Section 16 Planning Application No. A/SK-PK/310

Response to Departmental Comments Table

Section 16 Application for Proposed Temporary Public Vehicle Park (Private Cars Only) with Ancillary Electric Vehicle Charging Facilities, Eating Place, Drivers Lounge and Solar Panels for a Period of 3 Years at Lots 333 S.B RP, 346, 348 RP, 349 RP and 350 in D.D. 221, Tai Mong Tsai Road, Sai Kung, New Territories

Annex 1b : Revised Swept Path Analysis

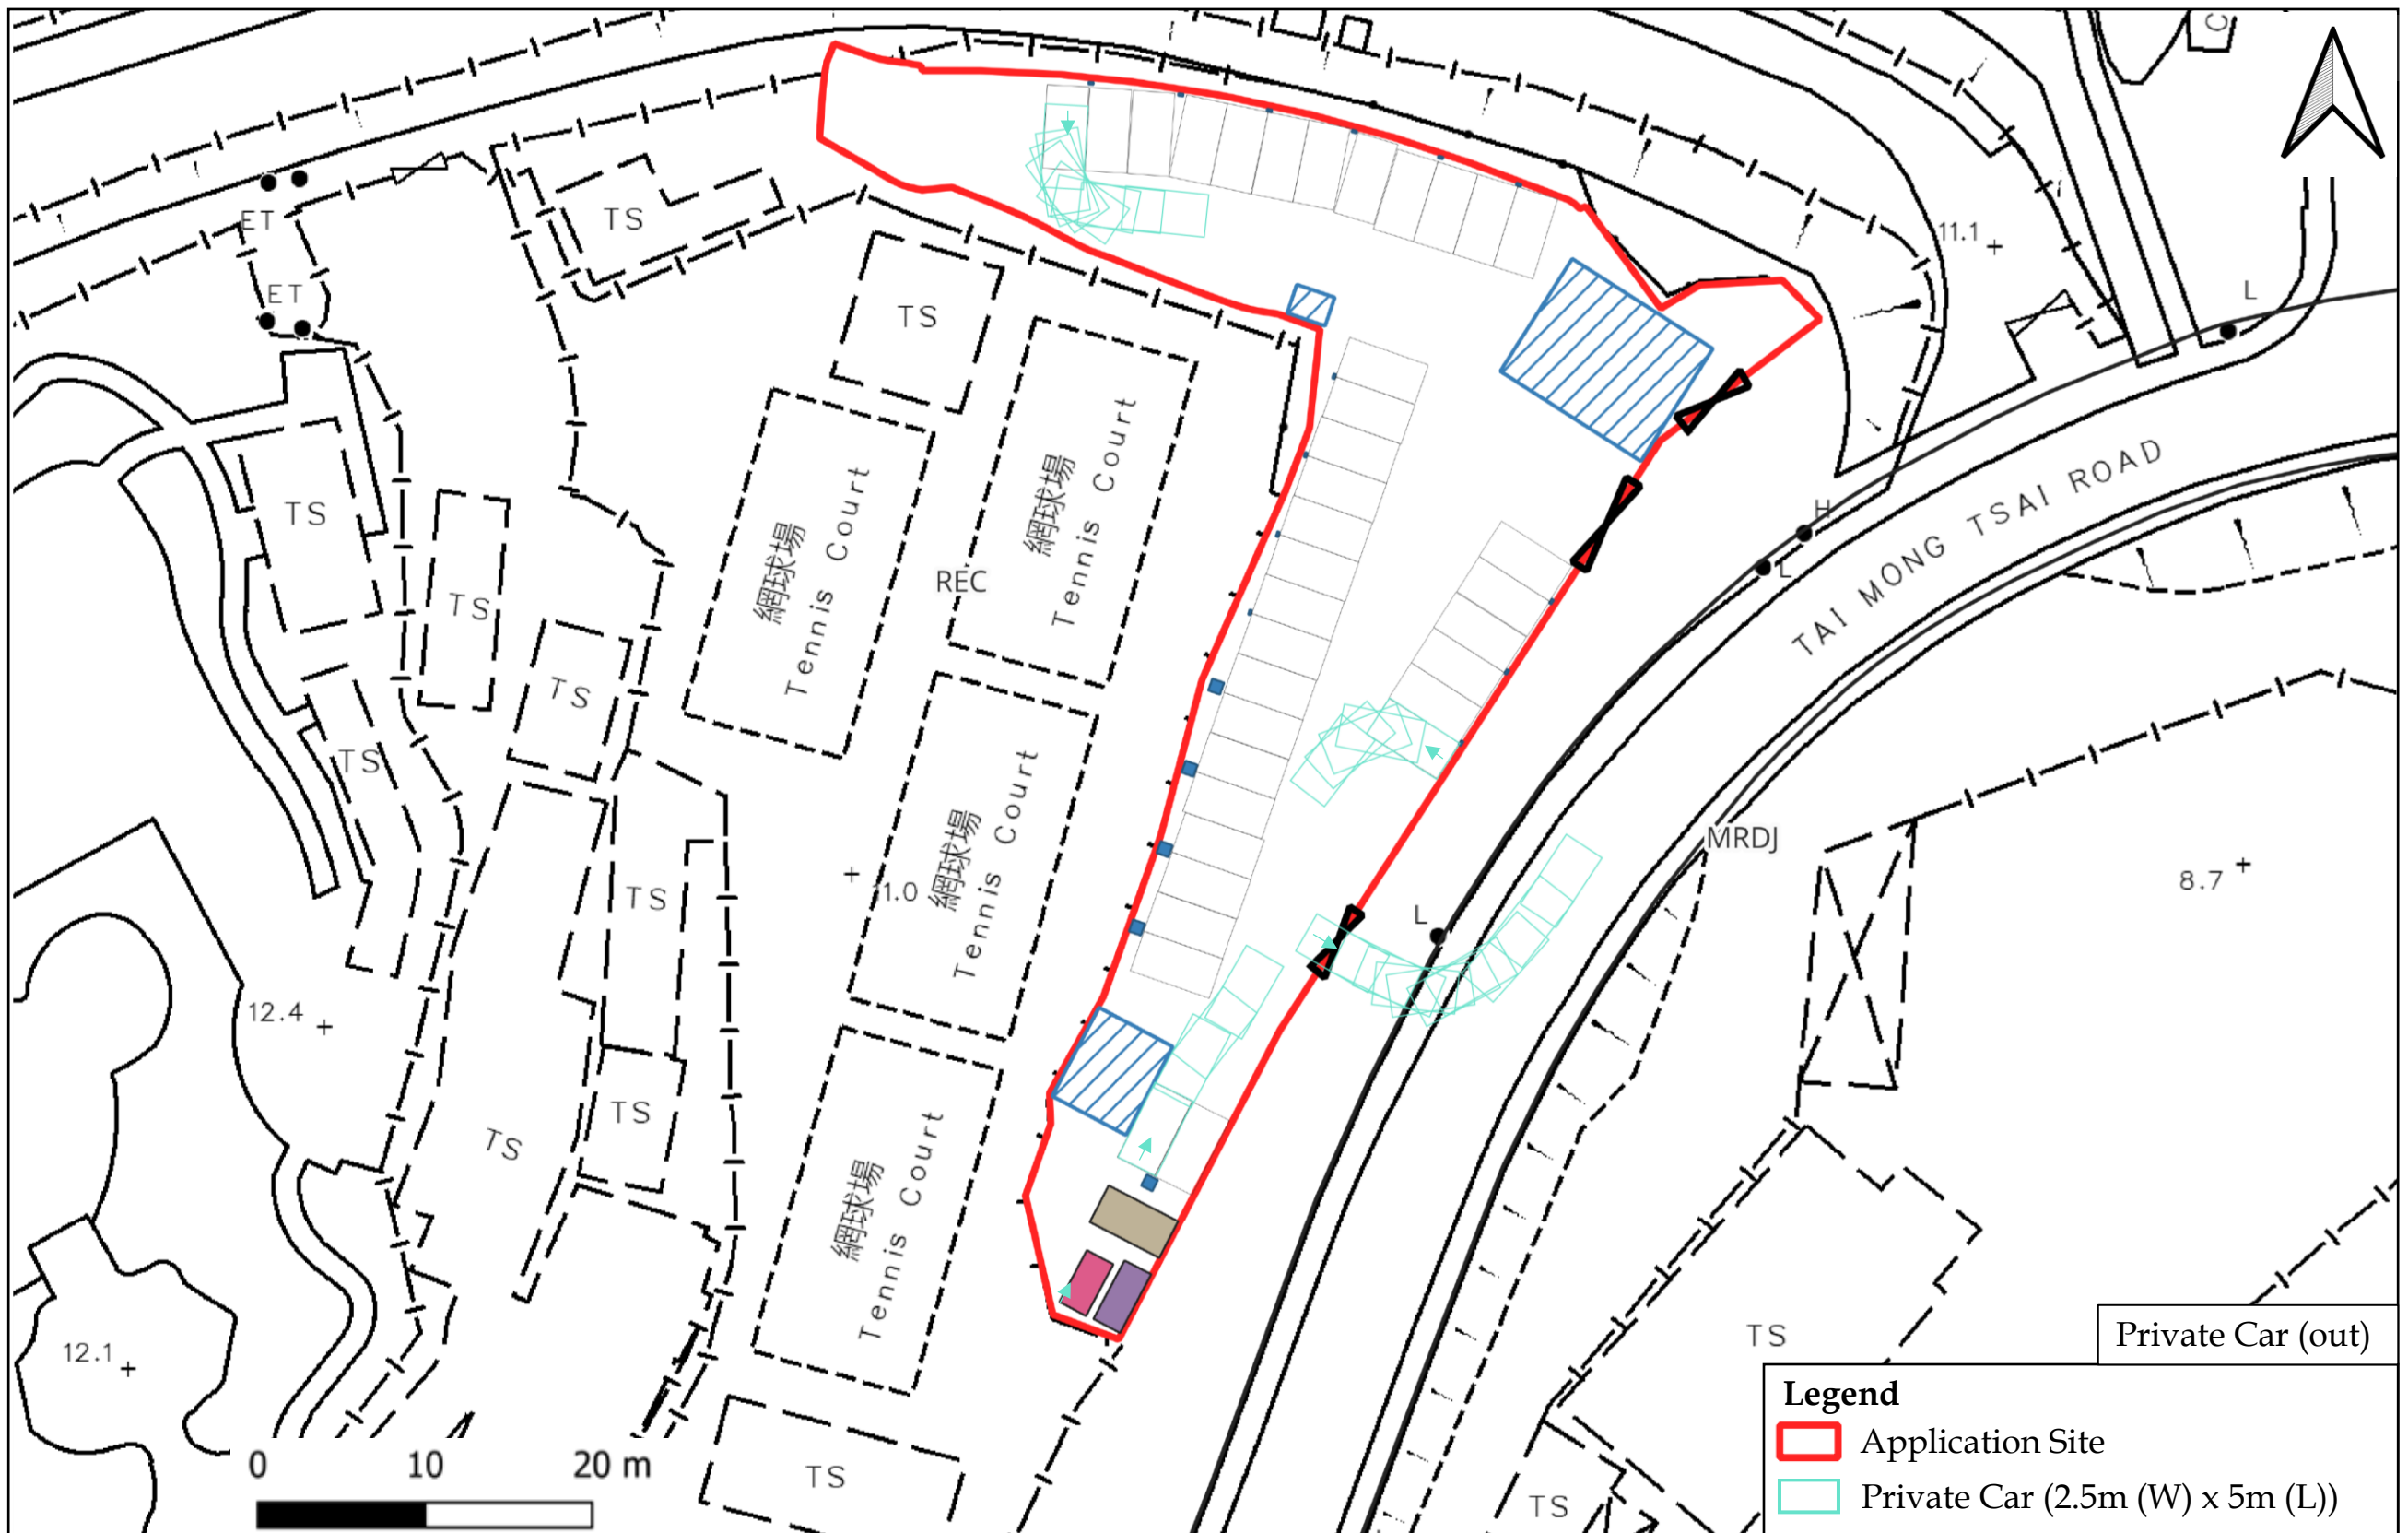
4.	The drawings submitted should be scaled drawings;	Comment noted, revised swept path analysis is at Annexes 3 .
5.	Please provide the sight distance at the proposed vehicular access; and	As shown in Annex 4 , the sight distance at the proposed vehicular access is not less than 50m (i.e. about 50m from run-in and about 55m from run-out respectively), which meets the minimum sight-distance requirement of 50m as stated in the Vol. 7 of the Transport Planning and Design Manual. Thus, adequate visibility can be provided from vehicles both driving in from Tai Mong Tsai Road and driving out from the Application Site.
